APPLICANT: Aggregate Material Hauling, LLC

PETITION NO.: SLUP-7

ZONING COMMENTS: **Staff Member Responsible:** John P. Pederson, AICP

SLUP-7 AGGREGATE MATERIAL HAULING, LLC

SURVEY FOR:
KEVIN JORDAN

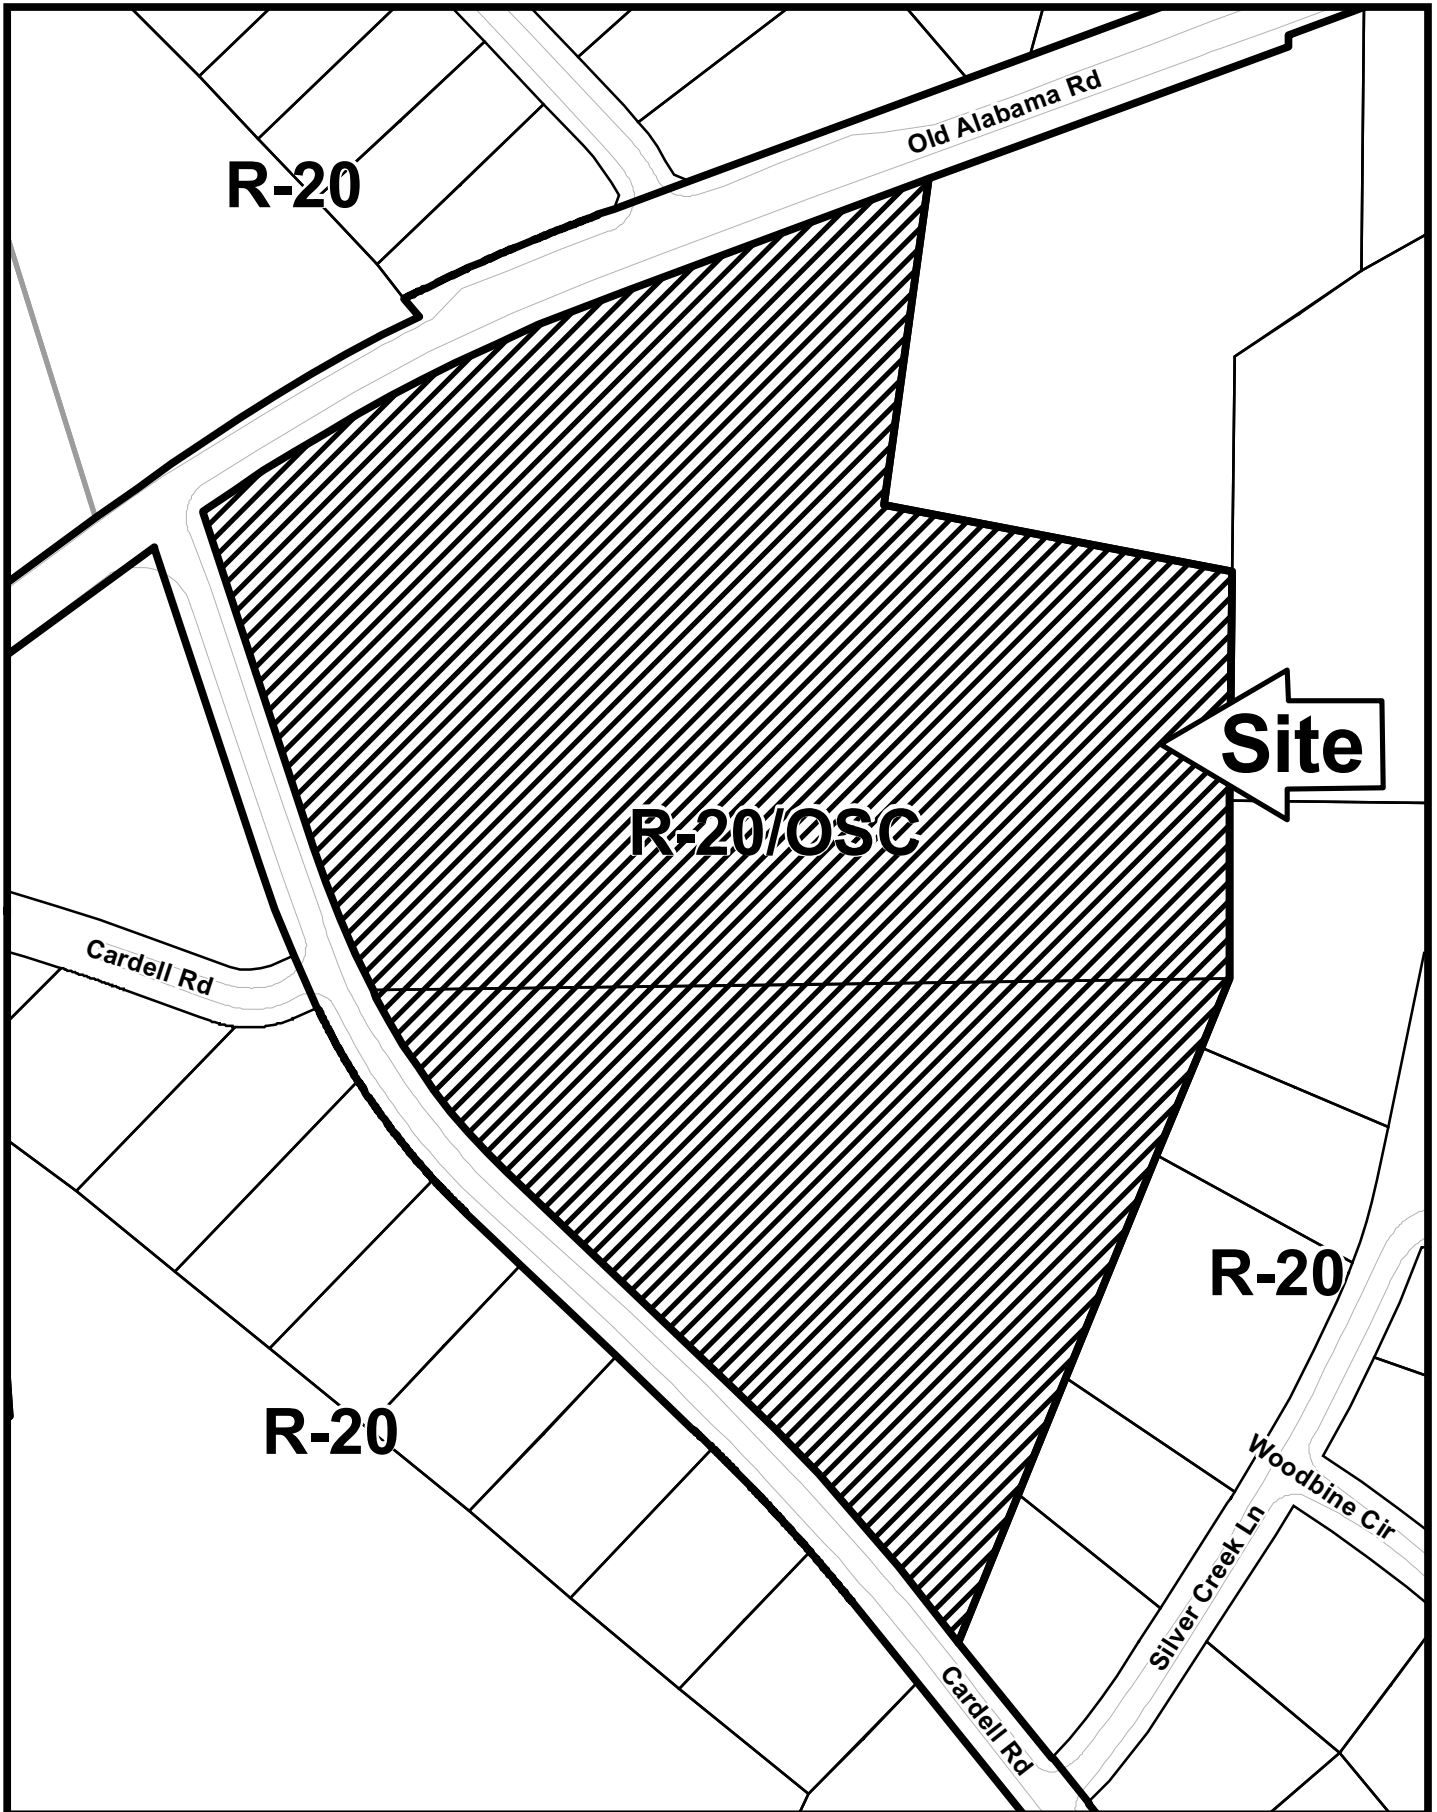
- No Stormwater controls shown.
- Copy of survey is not current – Additional comments may be forthcoming when current site conditions are exposed.
- No site improvements showing on exhibit.
